Well Name: MYSTERY AYM FEDERAL	Well Location: T20S / R25E / SEC 33 / NWSW /	County or Parish/State: EDDY / NM
Well Number: 1	Type of Well: CONVENTIONAL GAS WELL	Allottee or Tribe Name:
Lease Number: NMNM108454	Unit or CA Name:	Unit or CA Number:
US Well Number: 300153254100S1	Well Status: Gas Well Shut In	Operator: EOG RESOURCES INCORPORATED

Notice of Intent

Type of Submission: Notice of Intent	Type of Action Plug and Abandonment
Date Sundry Submitted: 06/04/2021	Time Sundry Submitted: 10:12
Date proposed operation will begin: 06/25/2021	
Procedure Description: Please see attached.

Revised P&A

Mystery AYM Federal 1 Proposed

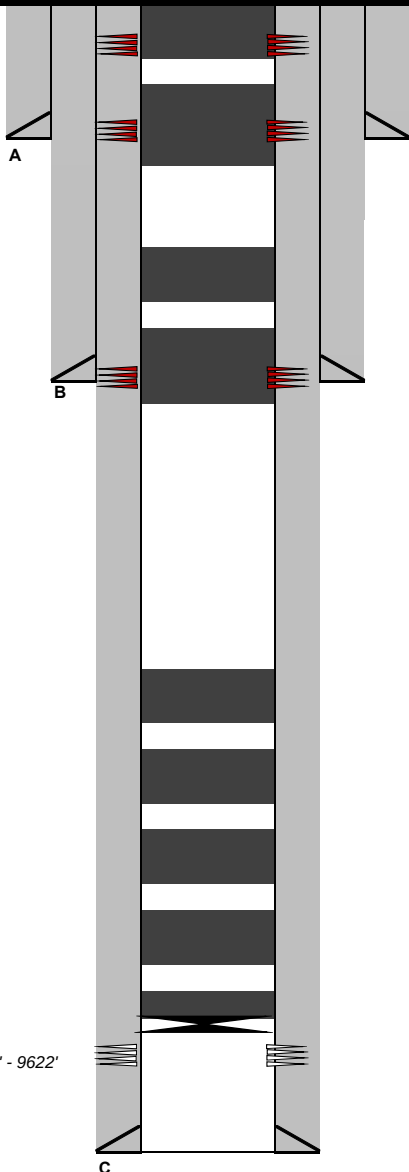
1. Set CIBP at 9444ft. Spot CI H cmt from 9444' - 9290'. (Pressure Test) **WOC & Tag(T/Morrow)**
2. Spot 25sx CI H from 9228'-9008'. **(T/Atoka)**
3. Spot 25 sx CI H from 8832'-8621'. **(T/ Strawn)**
4. Spot 25 sx CI H from 8302ft – 8615'. (T/ Canyon)
5. Spot 37 sx CI C from 6900' - 6700'. (T/Wolfcamp)
6. Spot CI C from 6600' - 5-6500'. (T/ 3rd BS)
7. Perf @ 3486'. Sqz 30 sx CI C from 3486'-3193'. **WOC & Tag (2nd BS)**
8. Perf @ 555' and Sqz 25 sx CI C from 555' - 704'. (T/San Andres)
9. Perf @ 100'. Sqz CI C from 100' – surface.
10. MLF between plugs- Above ground steel tanks will be utilized.
11. Cut wellhead off. Set Dry Hole marker.
